PROJECT NAME: MARBACH ROAD PH IIB
CIMS PROJECT NO. 40-00308

ADDENDUM NO. 1

Addendum No. 1 is issued to notify, add, change and replace the following:

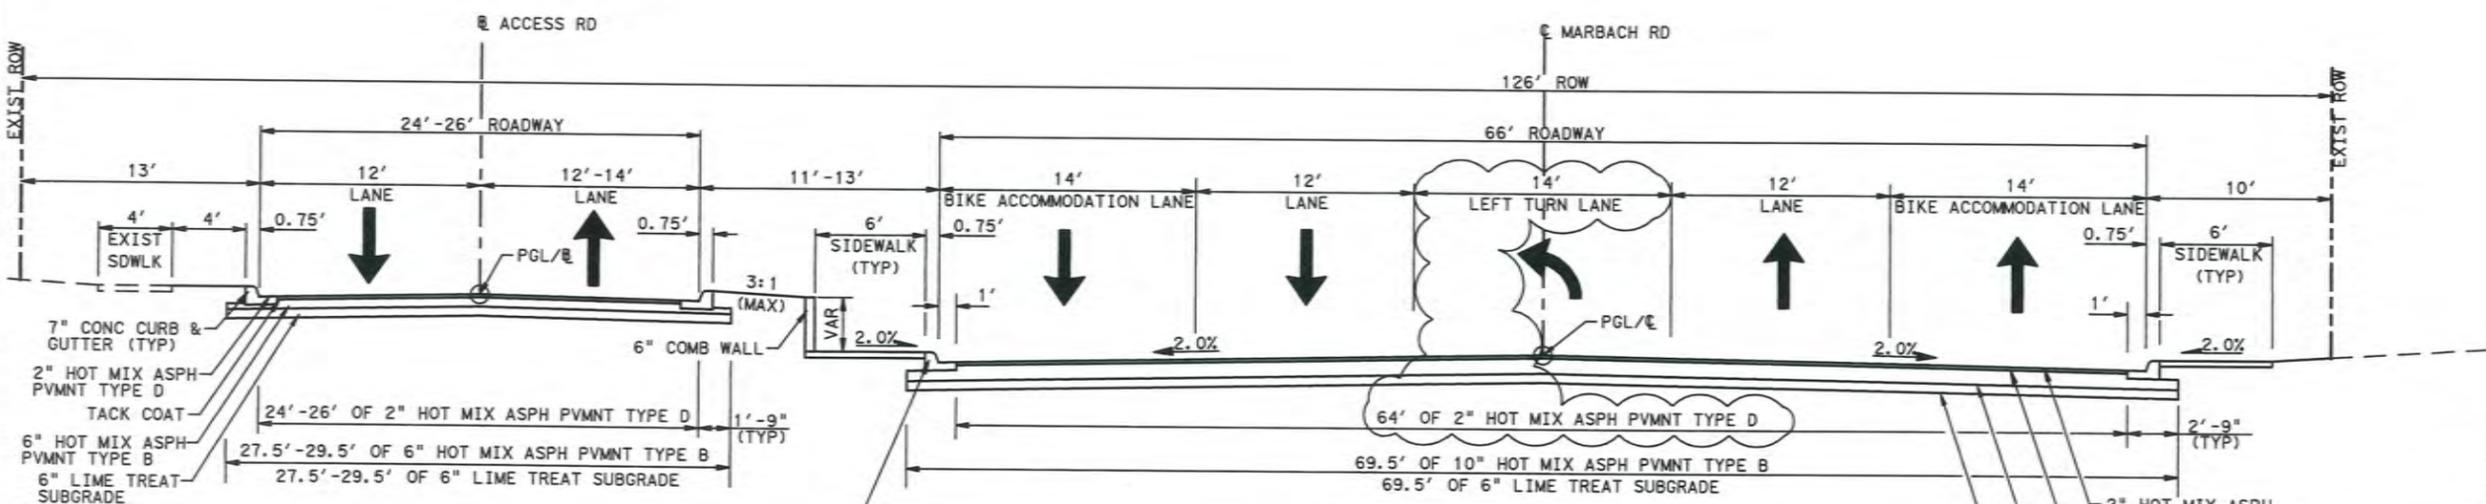
- 5) CoSA PLANS: The proposed median on Marbach Road was adjusted from Sta 80+50 to Sta 83+57. Replace the following Plan Sheets that reflect this change:
 - a. Sheet 7, Typical Sections
 - b. Sheet 12, Project Quantities Summary
 - c. Sheet 115, Roadway Plan & Profile
 - d. Sheet 122, Intersection Layout
 - e. Sheet 171, Signing & Pavement Markings

MARBACH RD (PHASE IIB)
FROM MEADOW WAY TO IH 410 FRONTAGE RD
ROADWAY PLAN AND PROFILE
MARBACH RD - STA 80+00.00 TO STA 84+00.00

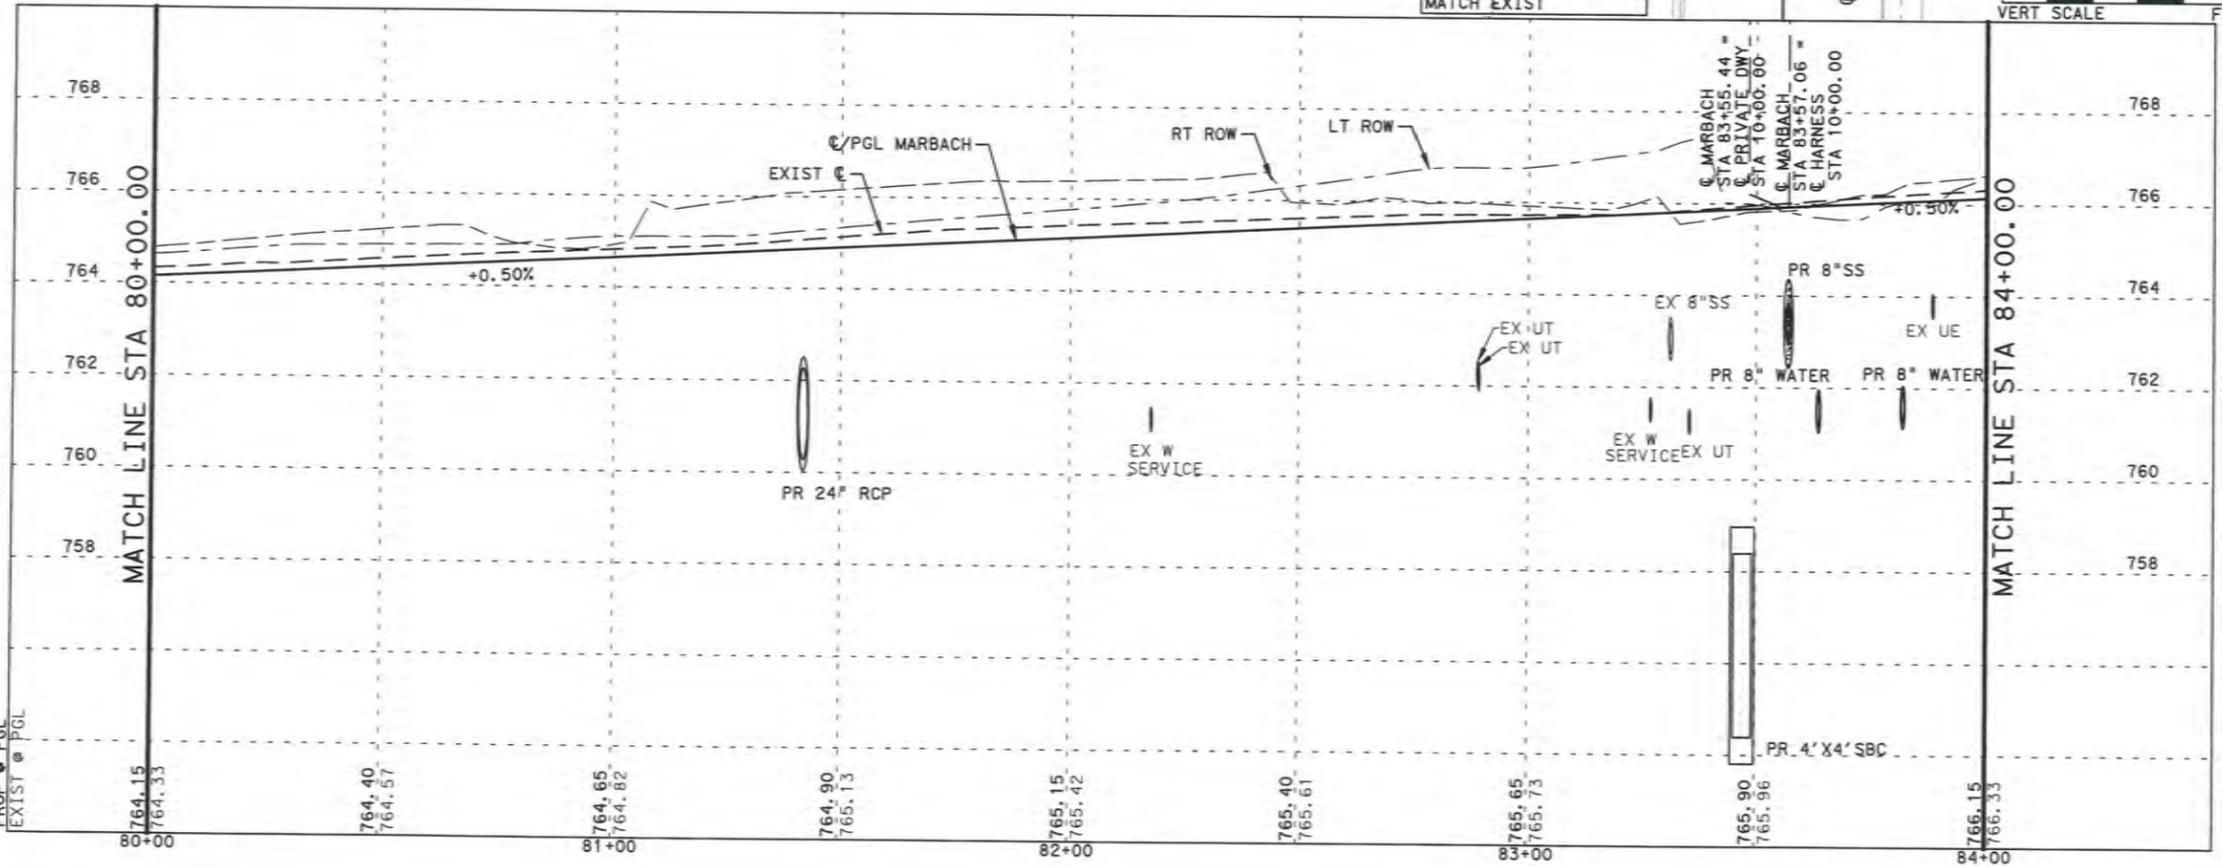
1	12-06-13	ADDENDUM 1 - REVISE MEDIAN & QUANTITIES	BMB
REV. NO.	DATE	DESCRIPTION	BY

SHEET: 122

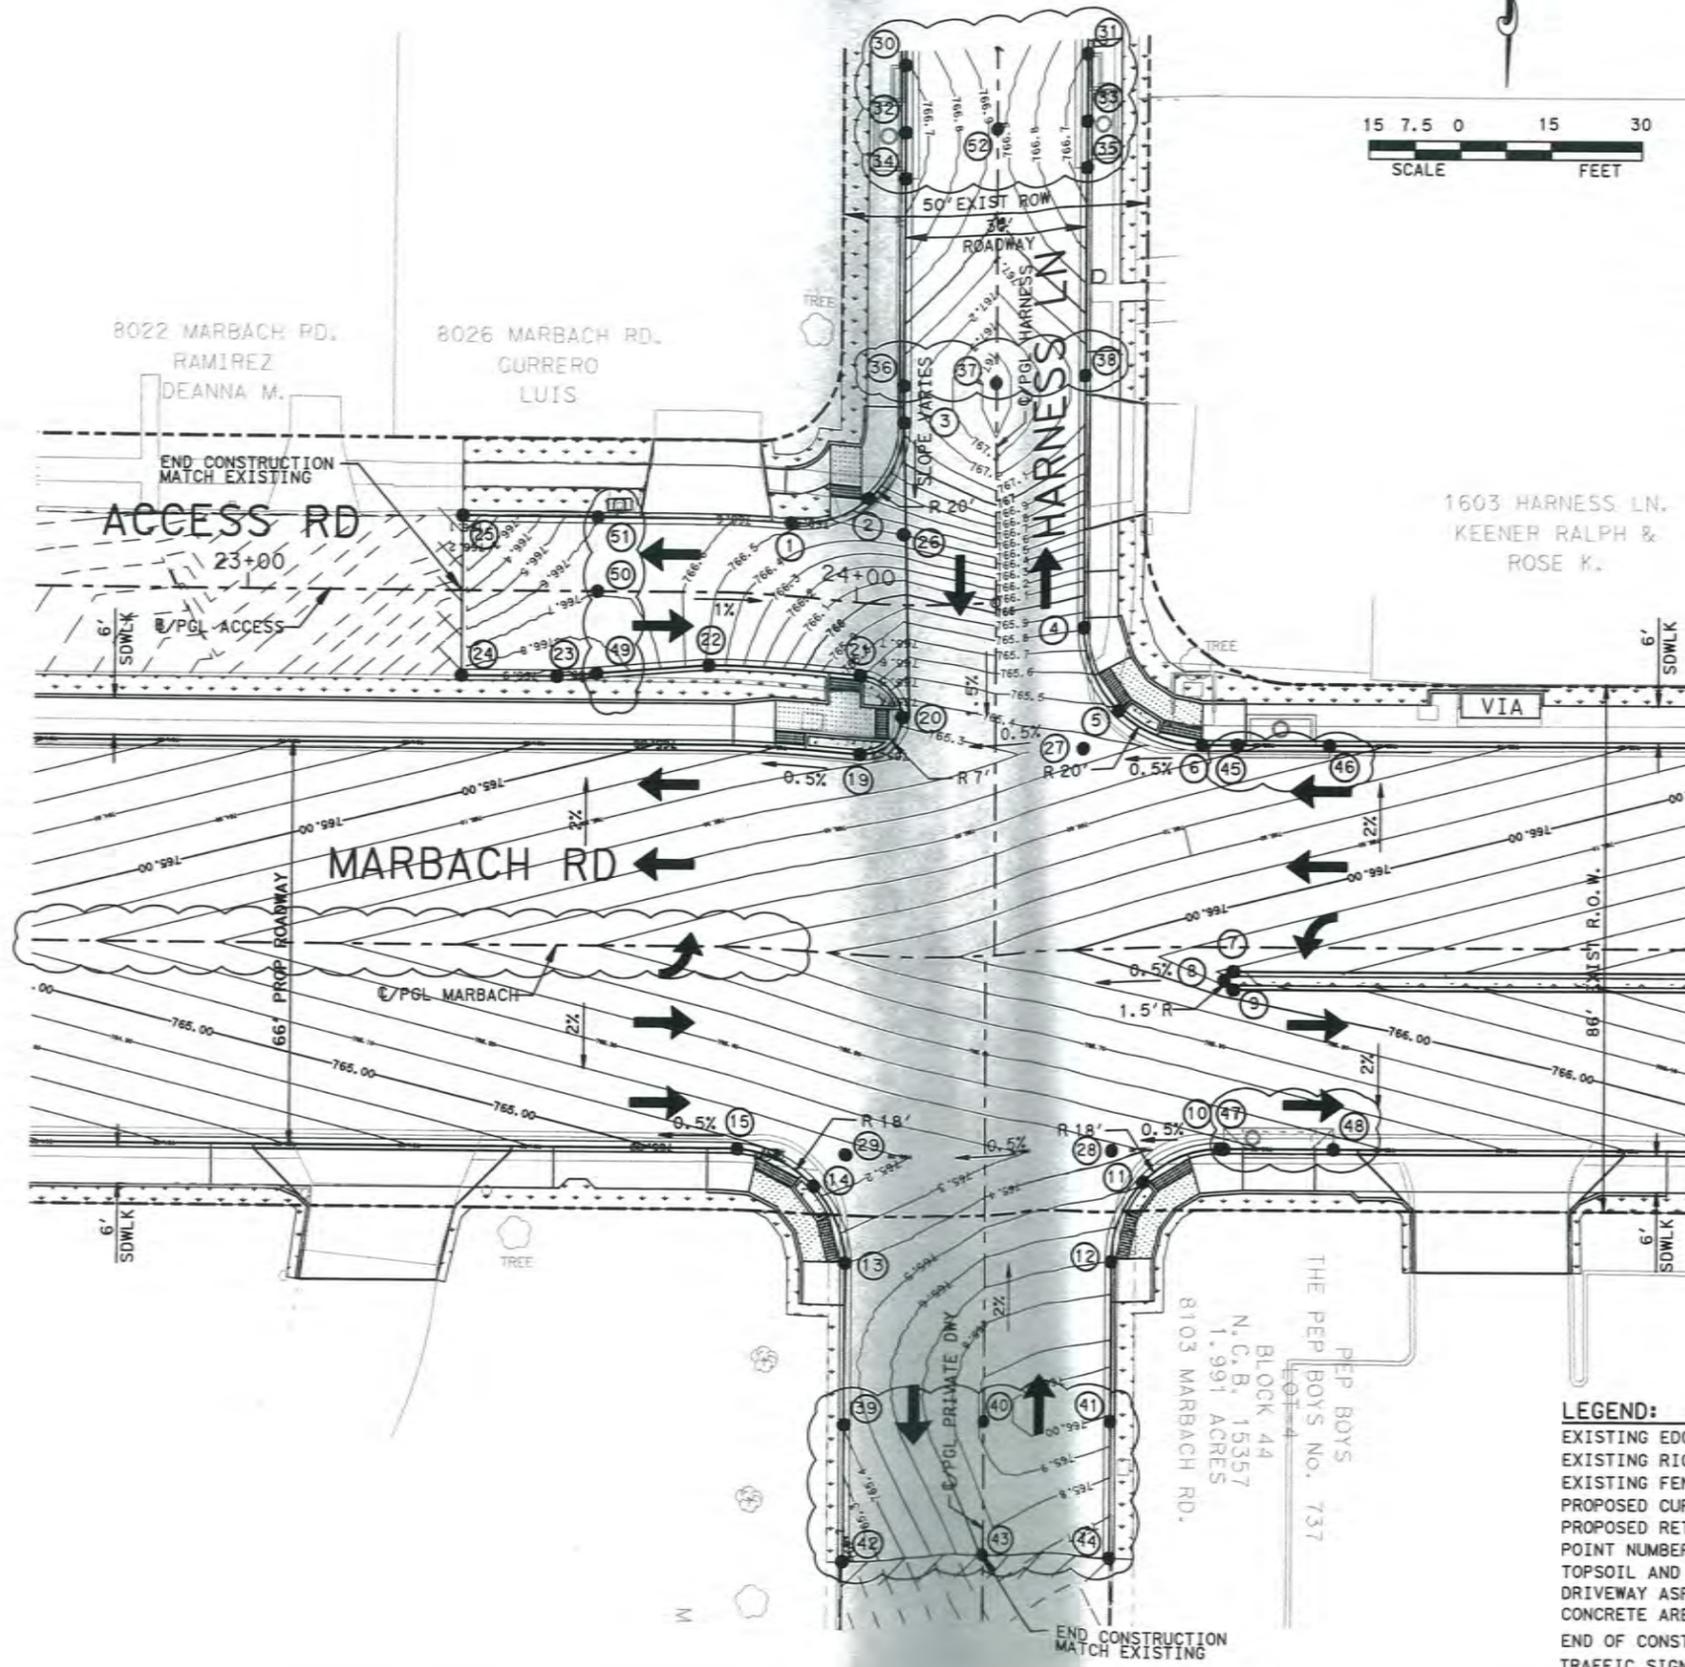
1	12-06-13	ADDENDUM 1- REVISE MEDIAN, ADD & OMIT POINTS	BMB
REV. NO.	DATE	DESCRIPTION	BY

FINAL SUBMITTAL	PROJECT NO: 40-00308	DATE: 12/6/2013
DRWN BY: CDA/MC	DSGN BY: SS/CDA	CHKD BY: LDM/CB
		SHEET: 171

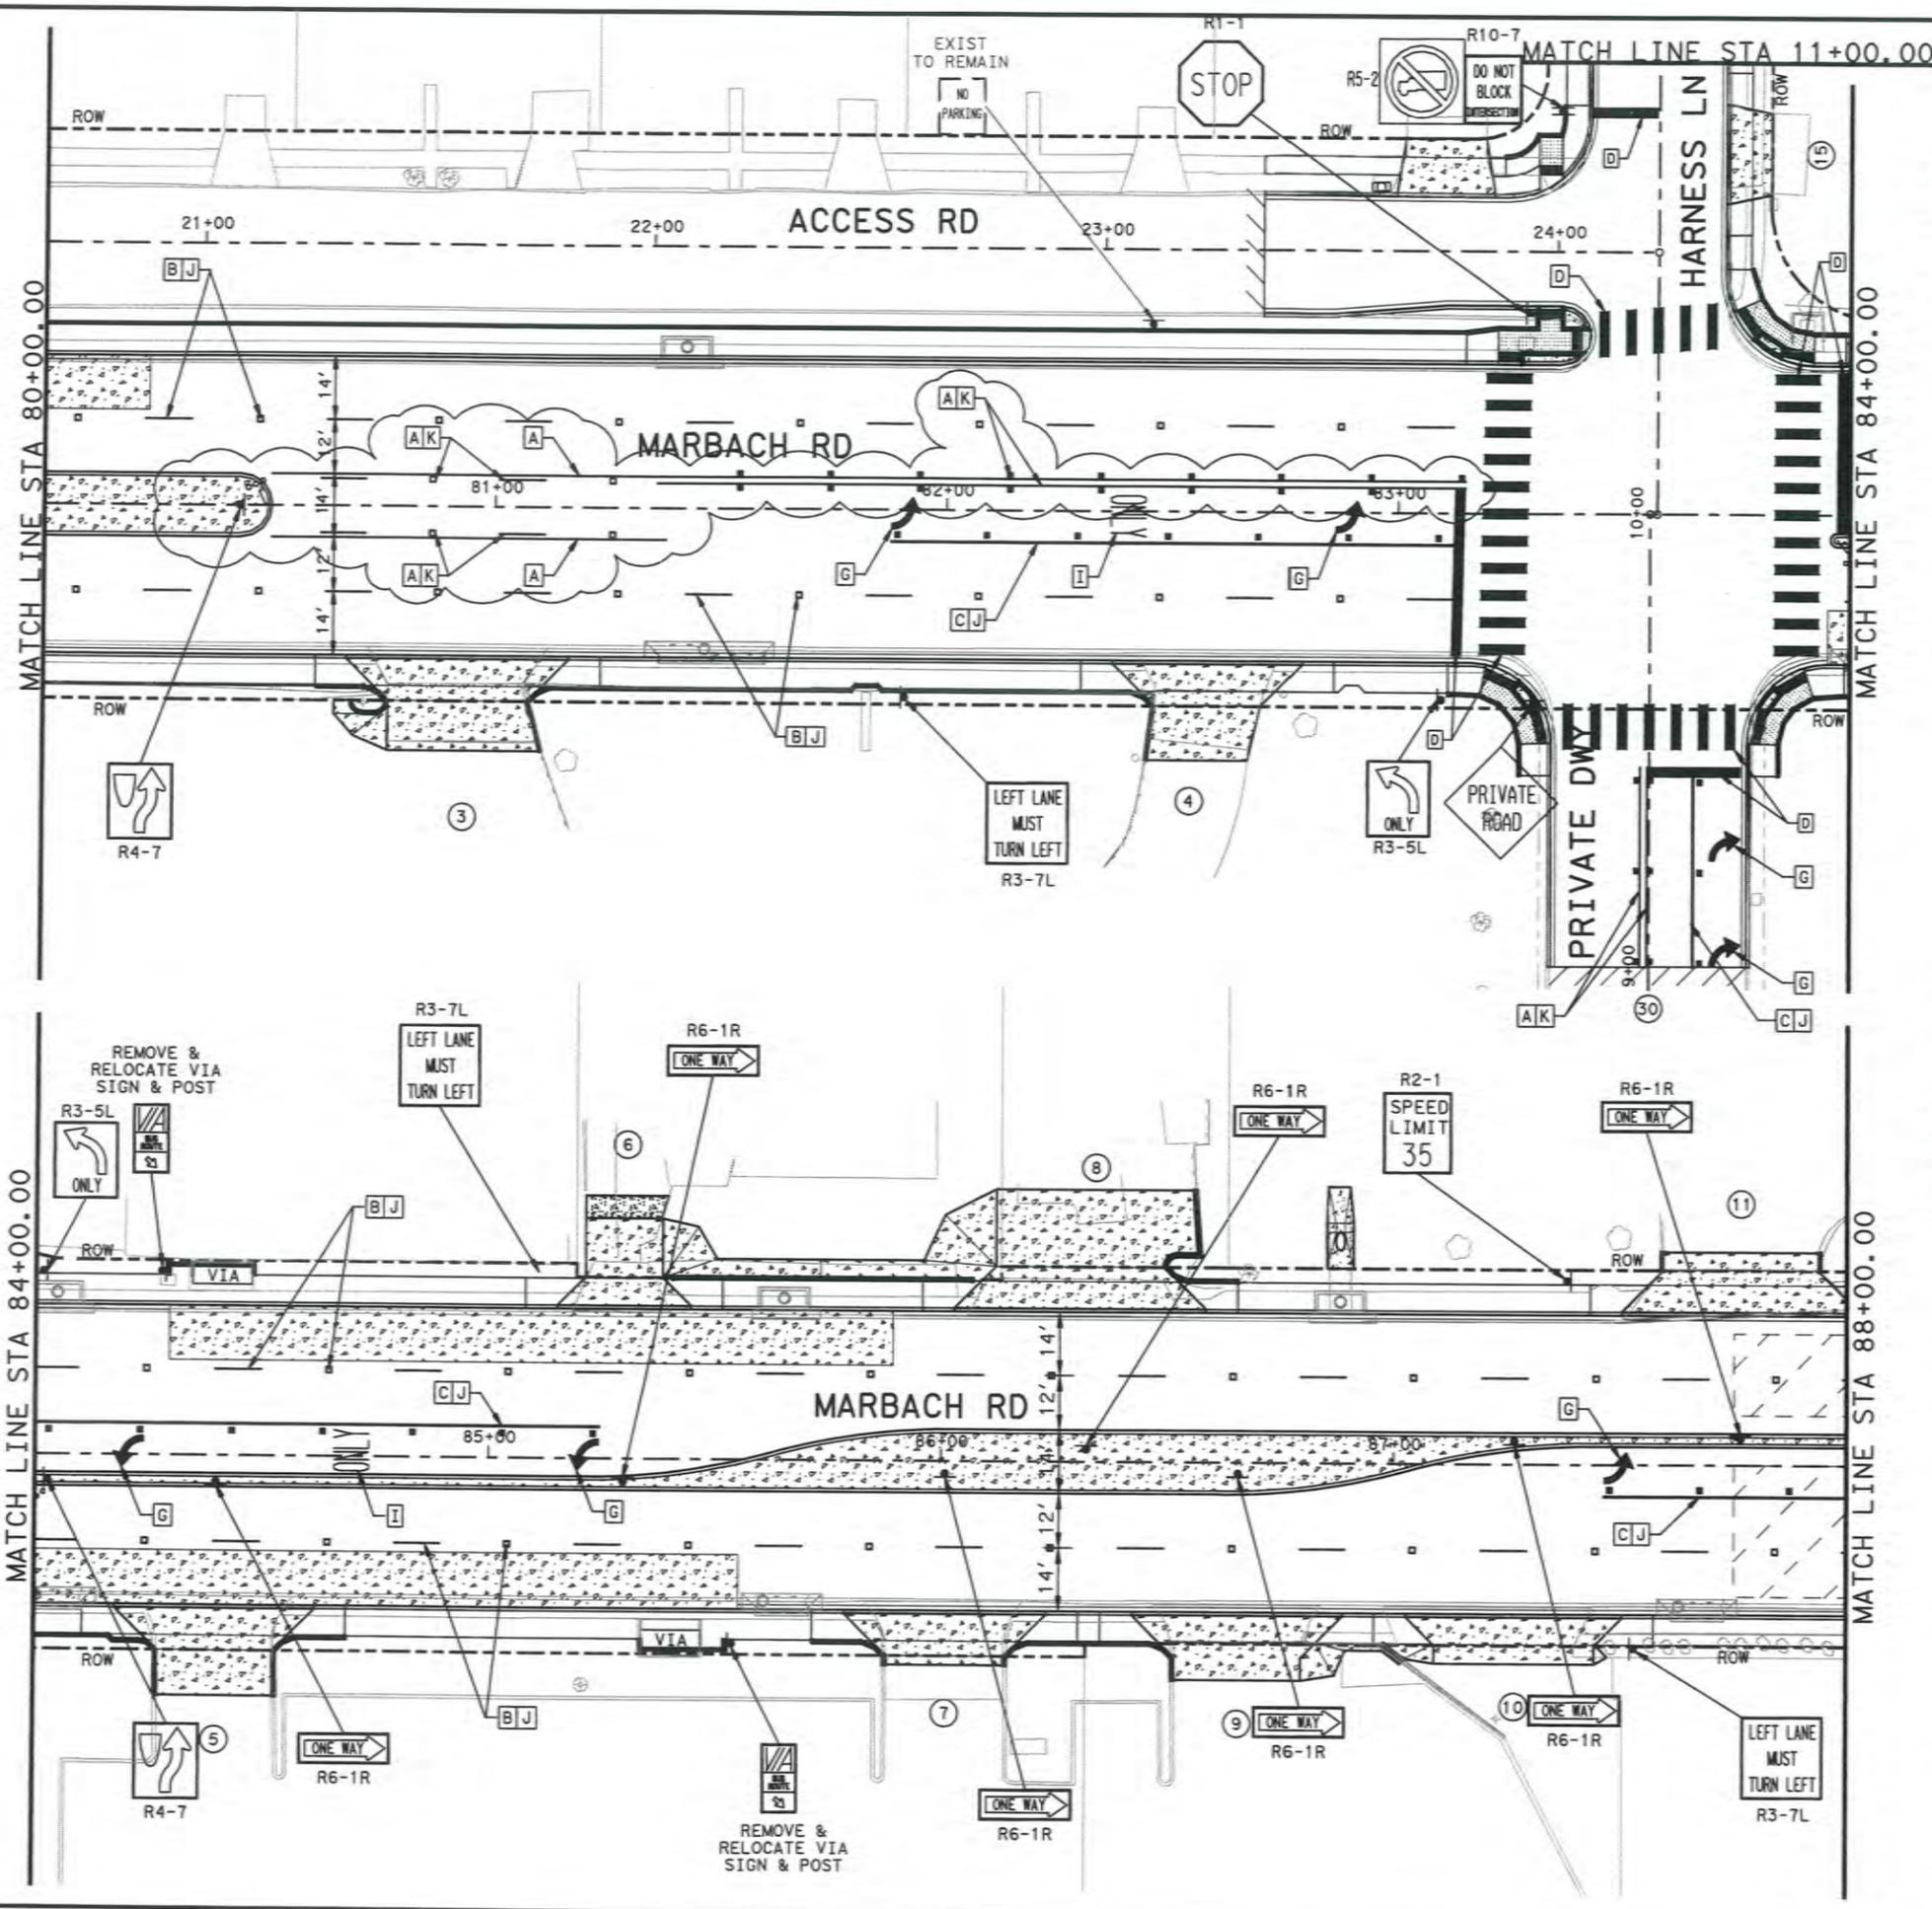
1	12-06-13	ADDENDUM 1 - REVISE MEDIAN, PAV MKR & QUANT	BMB
REV. NO.	DATE	DESCRIPTION	BY
